CS Memorandum No. 1378

Subject: Configuration Management Board Meeting No. 115

CMB Meeting Minutes #115

SUBJECT: Configuration Management Board Meeting # 115 – Rev. No. 0

| DRAWING NO. | JT-701 |

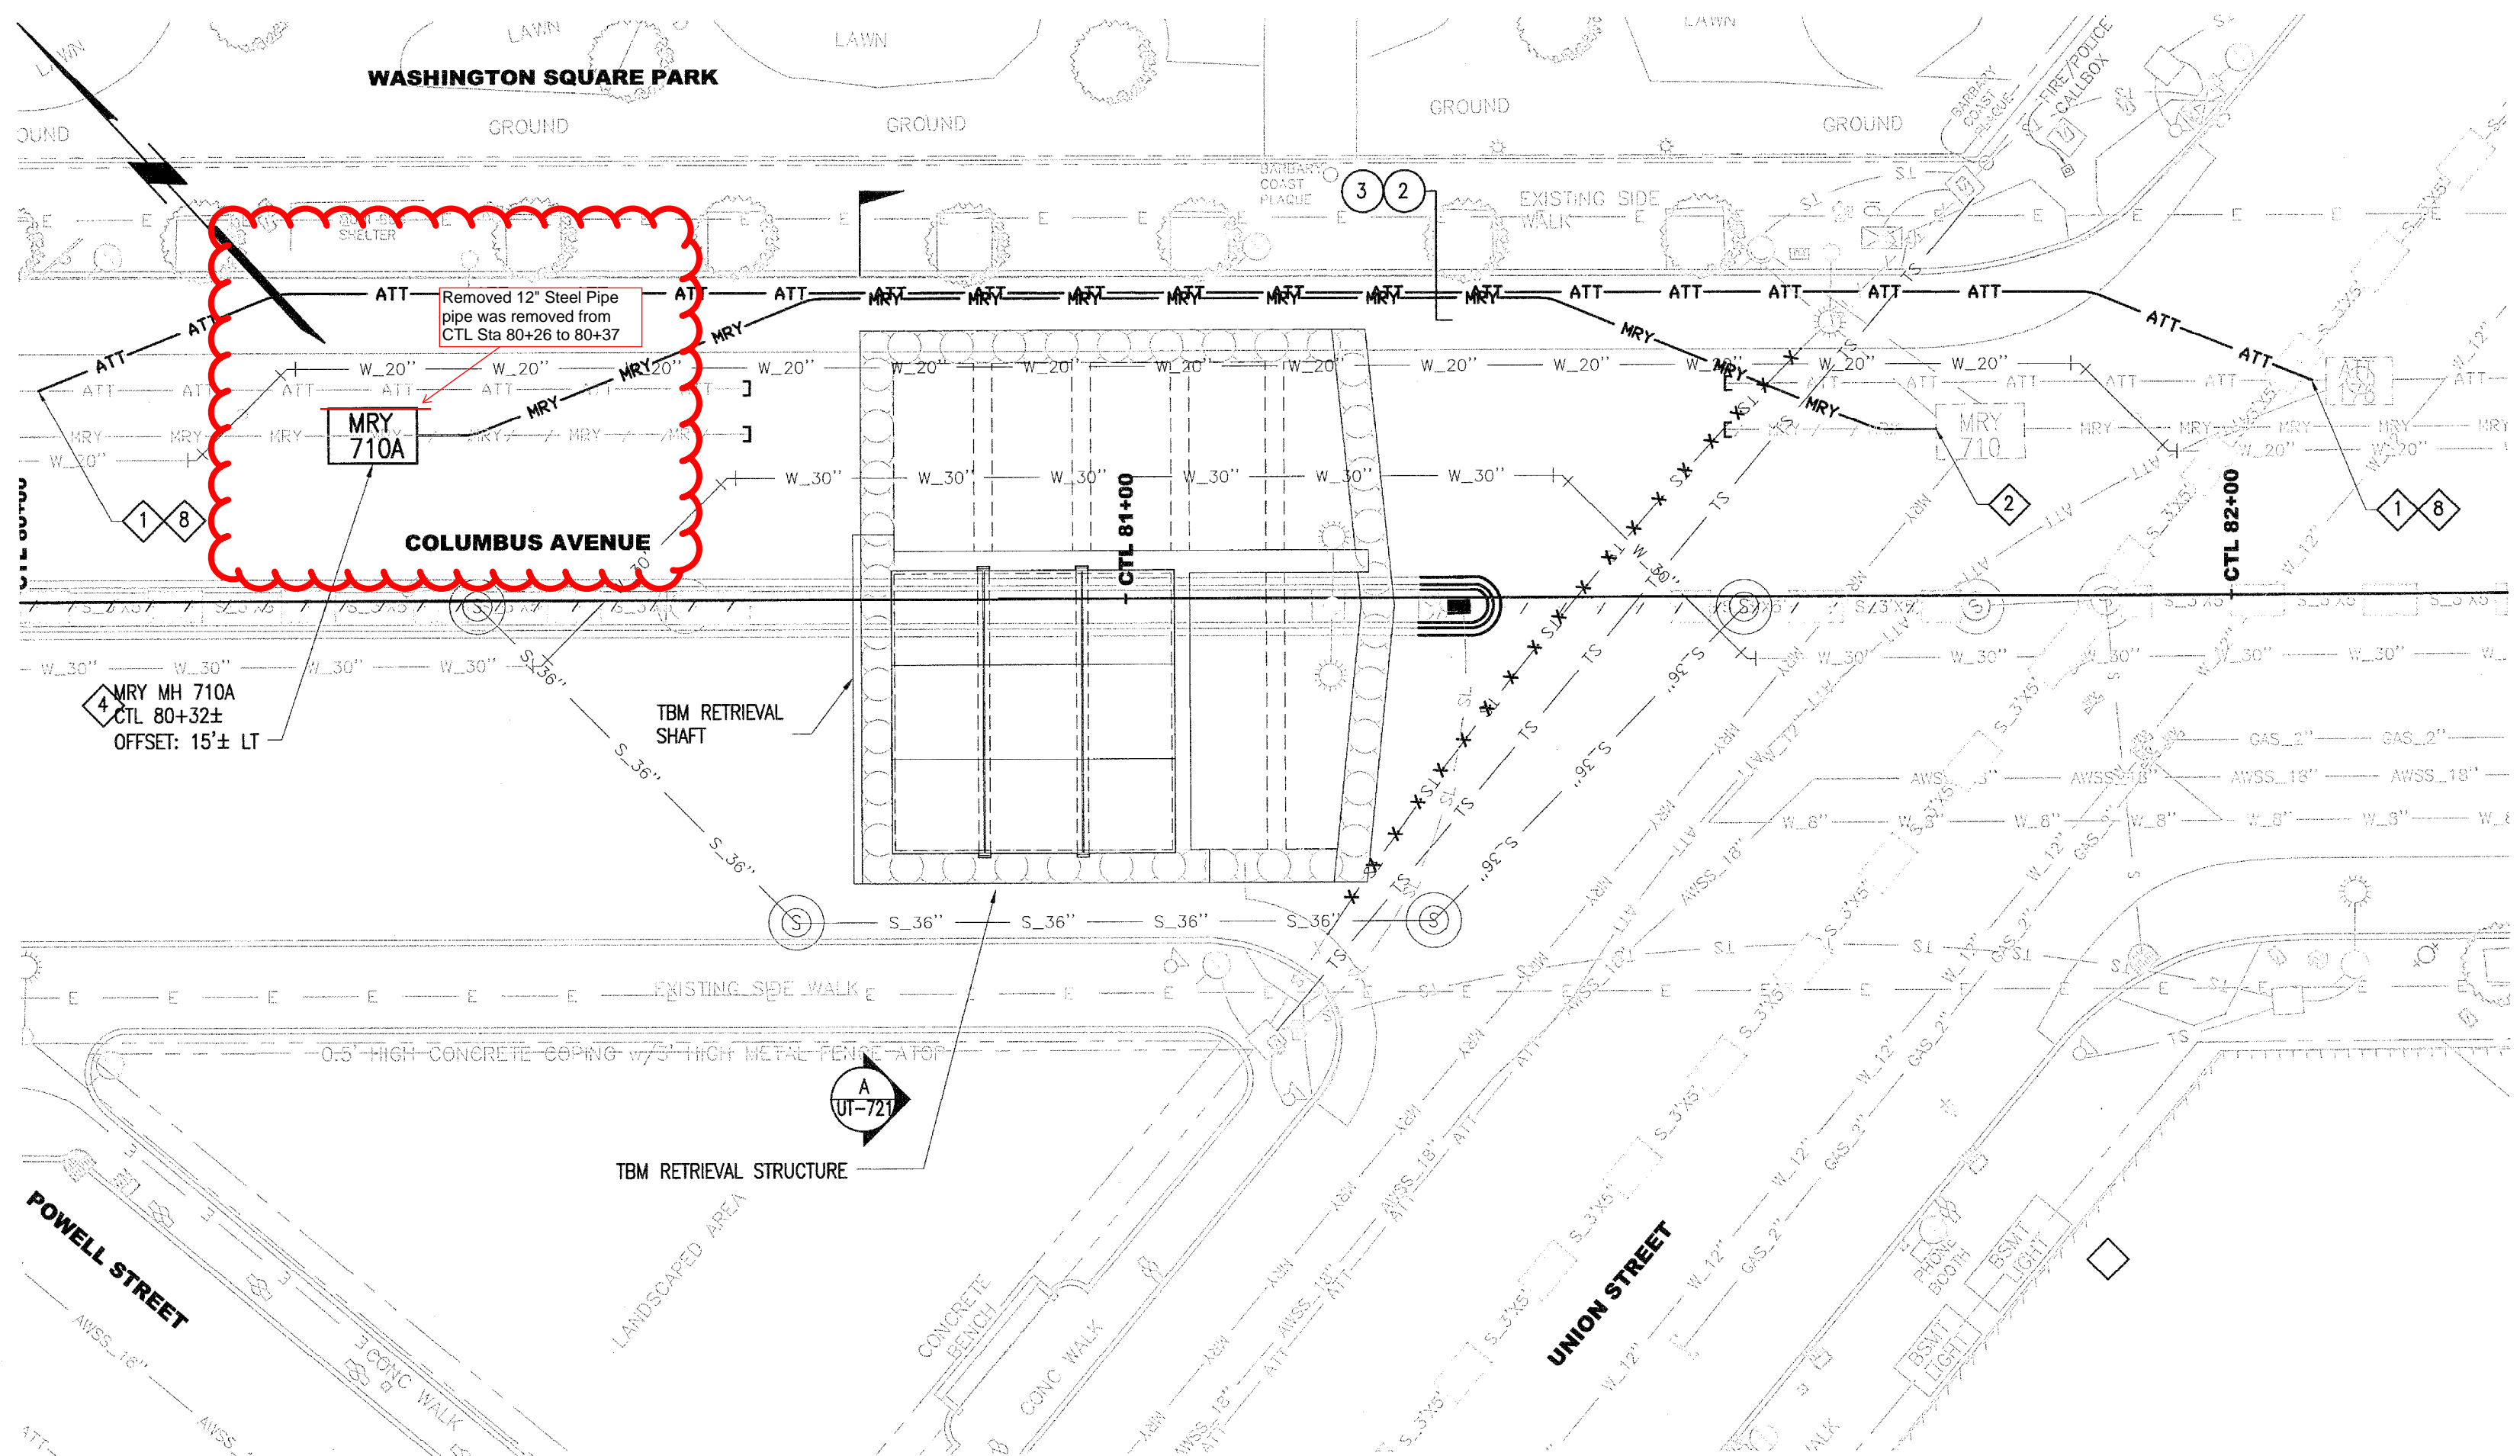
| GENERAL | | | |
|--|---|---|--|
| Impacts of Change | Retrieval Shaft – Unmarked 12” Steel Pipe | | |
| | Change Order Request (COR 031) Amount Not To Exceed \$1,250.00 | | |

Work Description: Removal of abandoned 12" pipe in contact with main turbine vault + 12" pipe not shown on plans. Columbus Ave. Main vault 707A 707B

Notes: 9' section of 12" CI pipe removed at main OH 707A location Sta 41+32

| | | | | DESIGNED: M. DEFORGE DRAWN: F. BAYANI CHECKED: D. ZUJIRING REVIEWED: M. CHAN RECOMMENDED: M. FOWLER APPROVED: R. EDWARDS DATE: JAN 21 2011 | | APPROVED EXECUTIVE DIRECTOR/CEO | | DRAWING NO. UD-701 | | SHEET NO. 88 | |

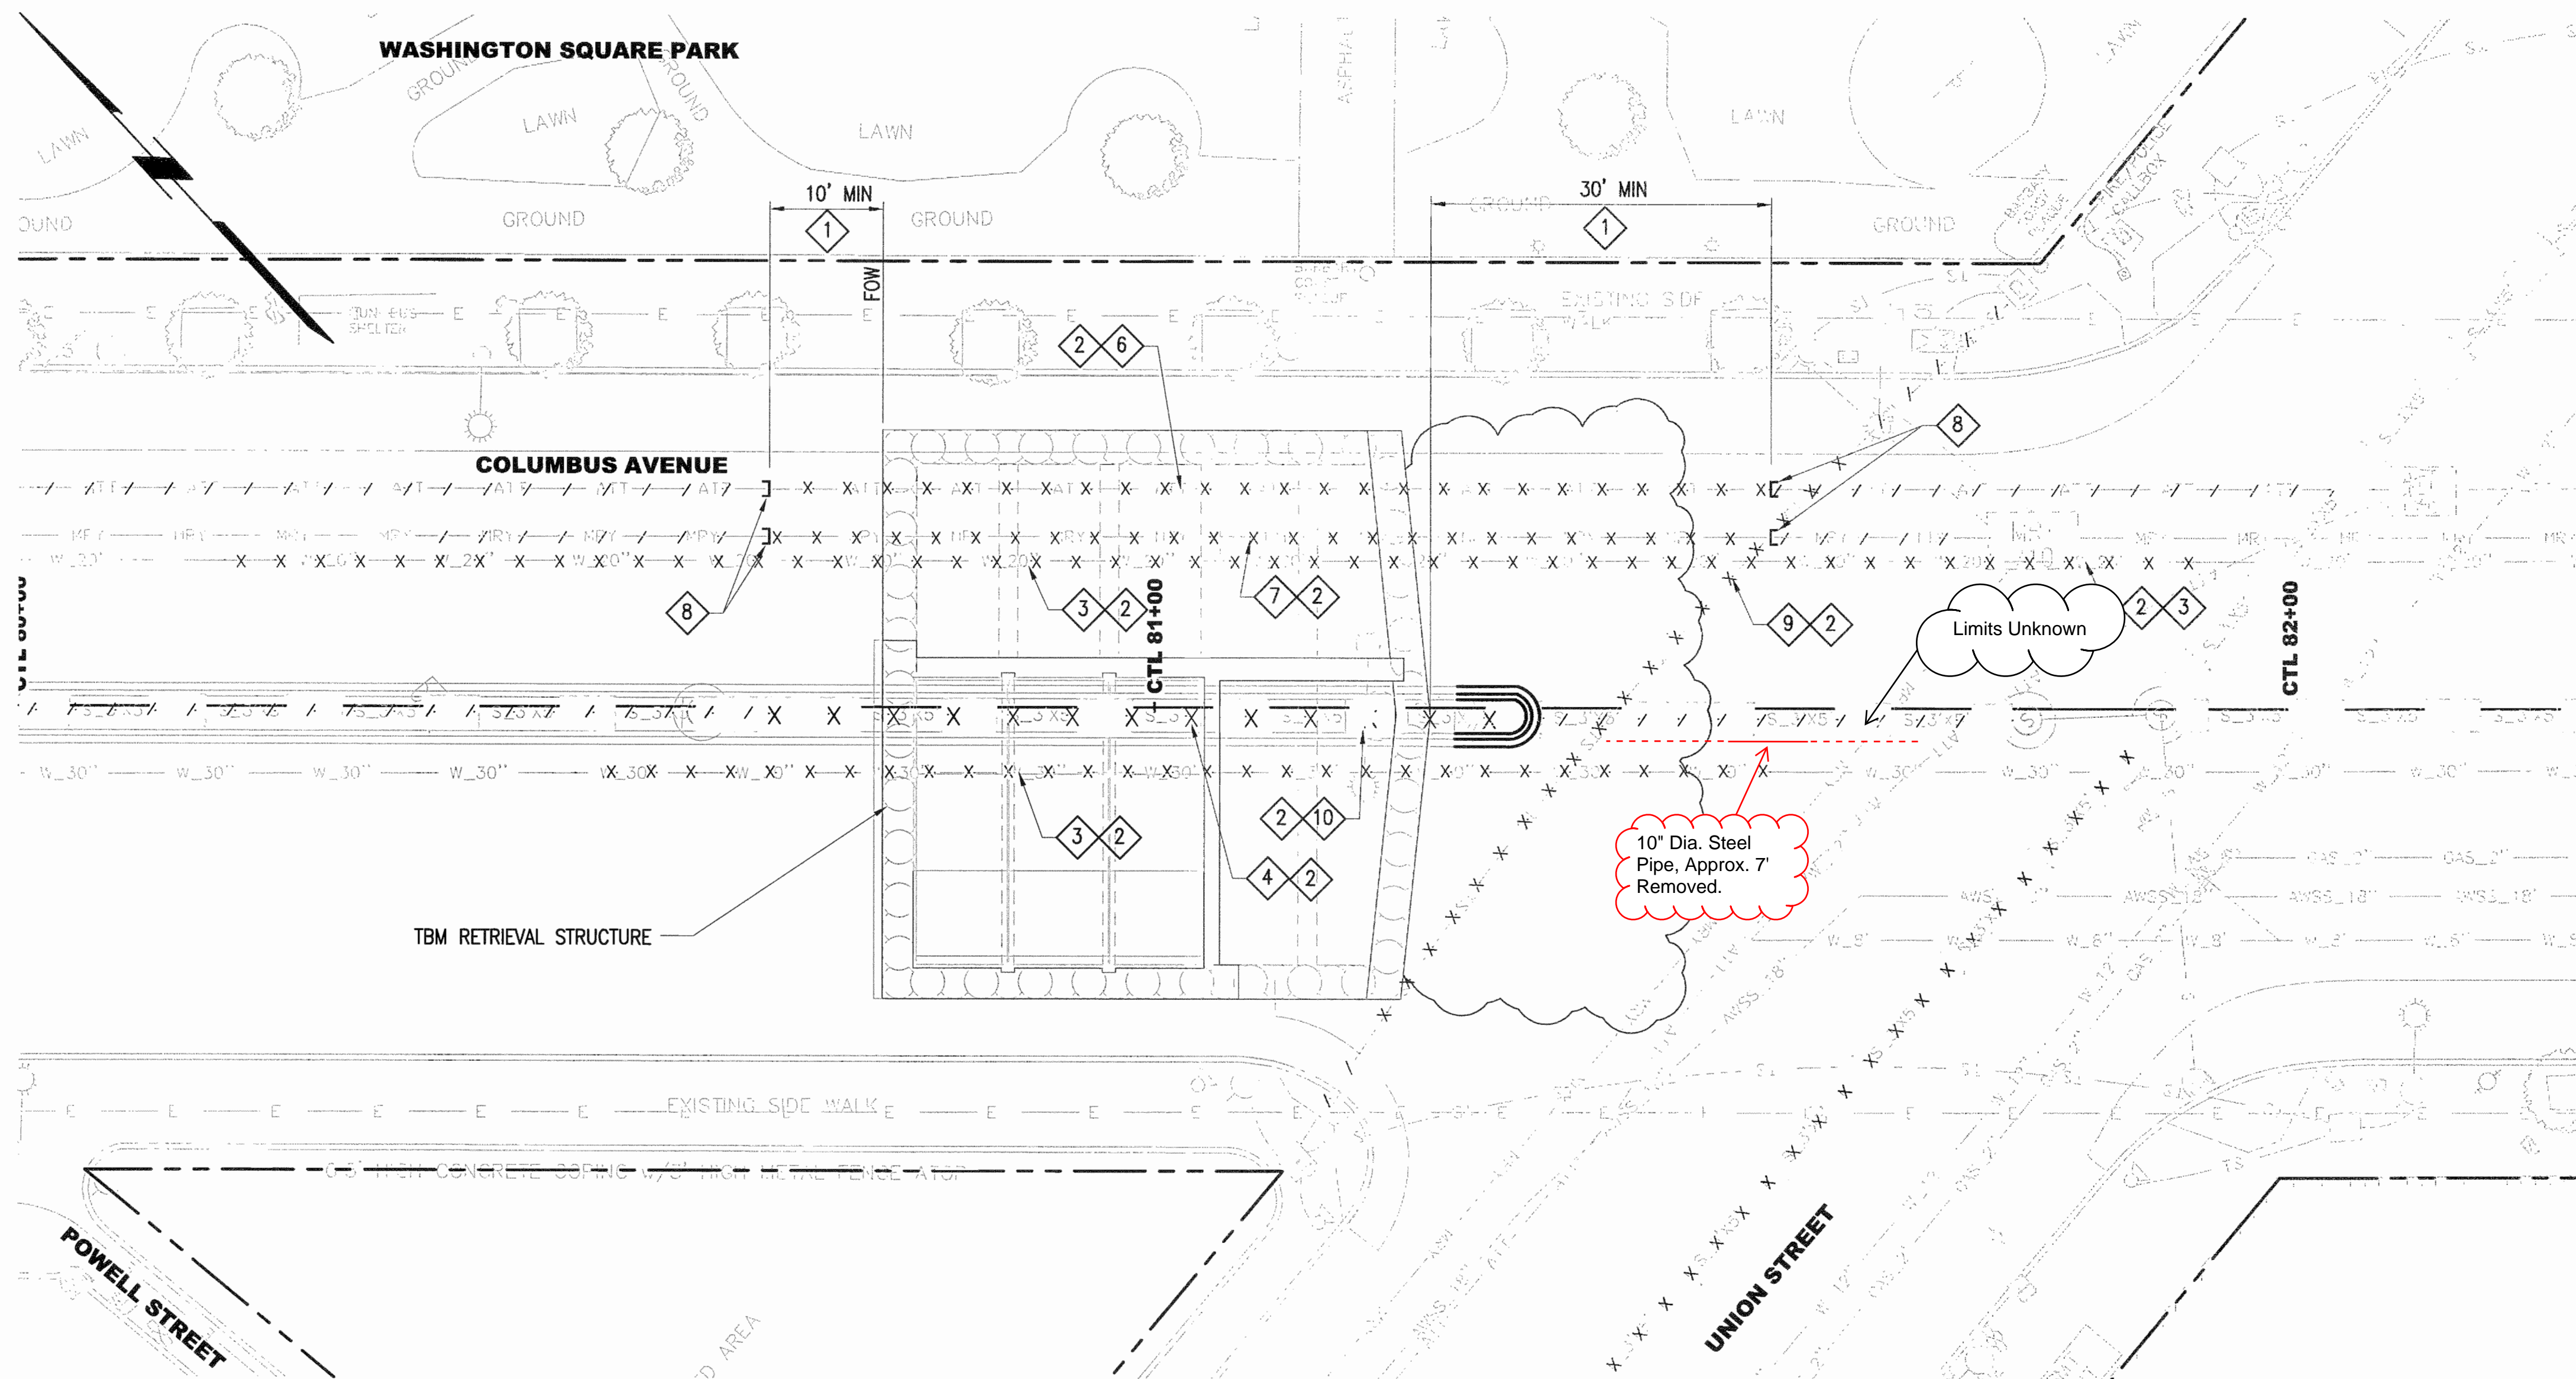
| GENERAL | | | | | | |
|---|---|---|--|--|--|--|
| Impacts of Change | <u>Add'l 10" MOS - 12" Steel pipe removal at Union/Columbus</u> | | | | | |
| Change Order Request (COR 058) Amount Not To Exceed \$860.85 | | | | | | |

General Scope: This estimate encompasses the cost to remove a 10" steel pipe at the intersection of Union and Columbus streets. This occurred at CTL Sta. 81+67 on 10/18/12.

Work Description: *Removal of 12" Steel Pipe @ danded man
 in the intersection of Union Columns. (FF was
 removed. *Steel pipe not shown on plans.*

| DRAWING NO. UD-701 |

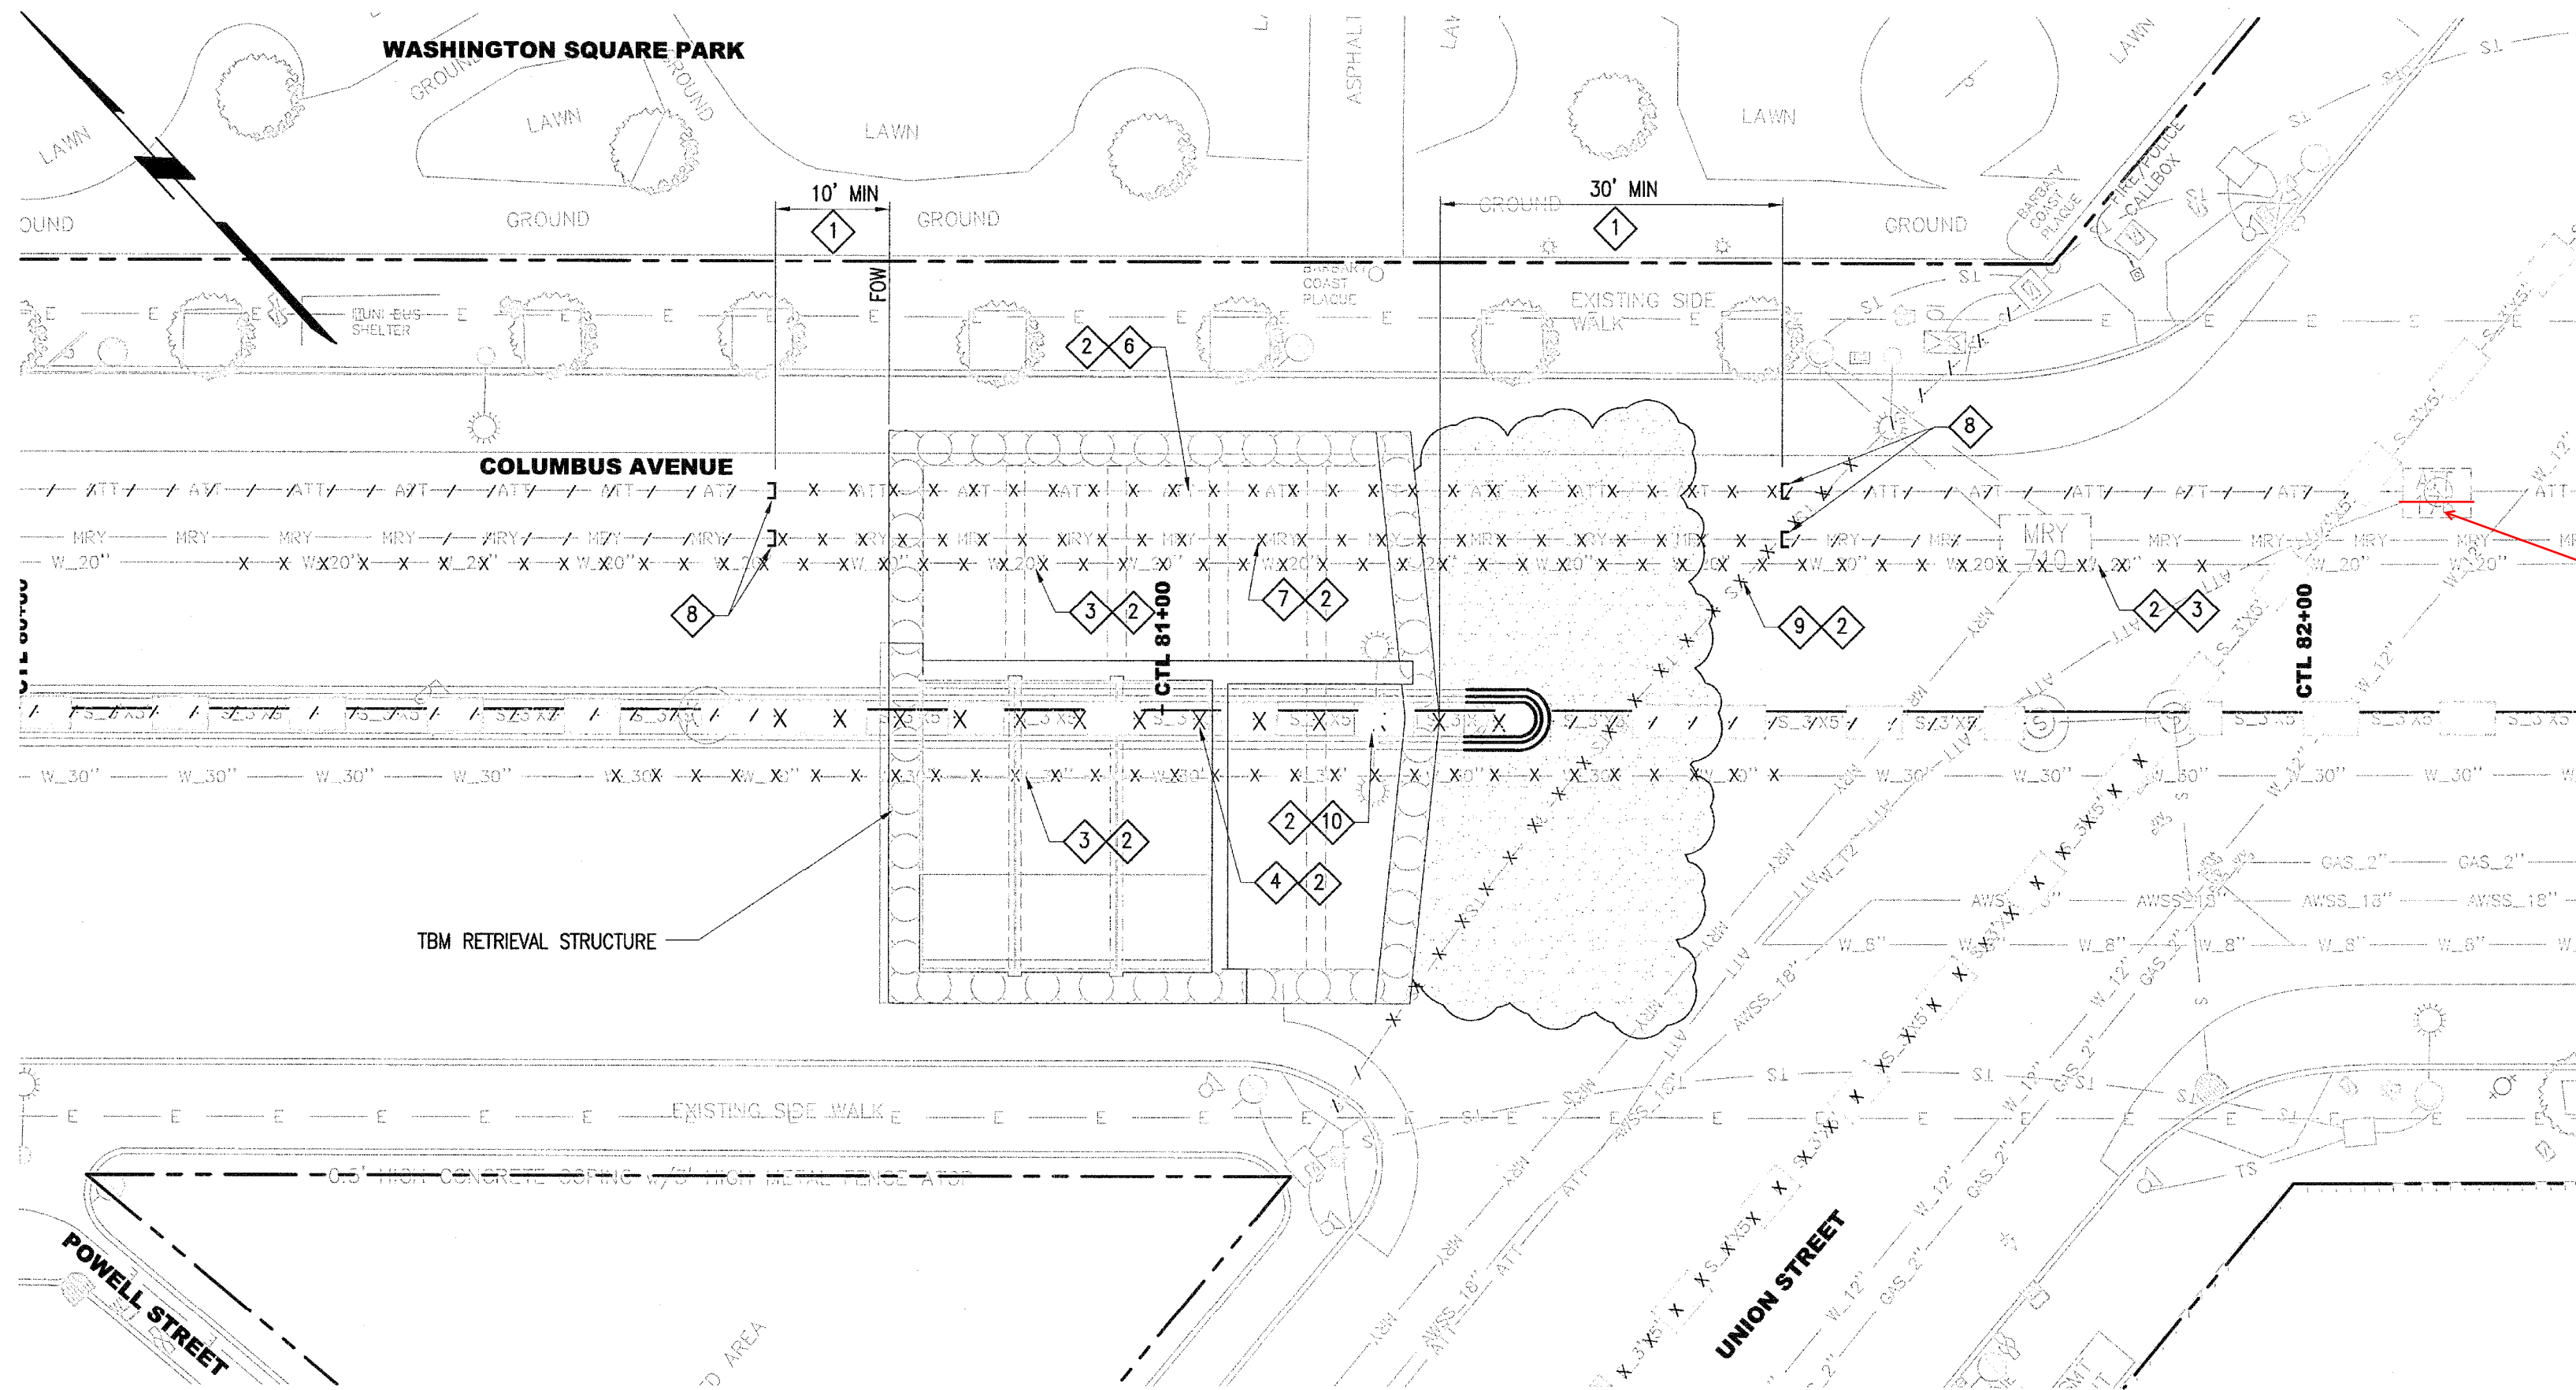
| GENERAL | | | | | | |
|---|---|---|--|--|--|--|
| Impacts of Change | MOS - 12" Steel pipe removal intersection of Union and Columbus St. | | | | | |
| | Change Order Request (COR 066) Amount Not To Exceed \$3,800.00 | | | | | |

General Scope: This estimate encompasses the cost to remove a 12" steel pipe at the intersection of Union and Columbus streets. The work was performed by a 1st tier subcontractor and tracked using a force account tag.

Work Description: Remove 12" steel pipe ATT vault @ Union & Columbus.

Facts: On November 21st 2012, The Contractor removed an abandoned 12” steel pipe from AT&T vault No.176 at the intersection of Union Street and Columbus Avenue. The removal of the 12” line was needed to provide access for AT&T to make connections inside this vault. A time extension has not been requested for this work.
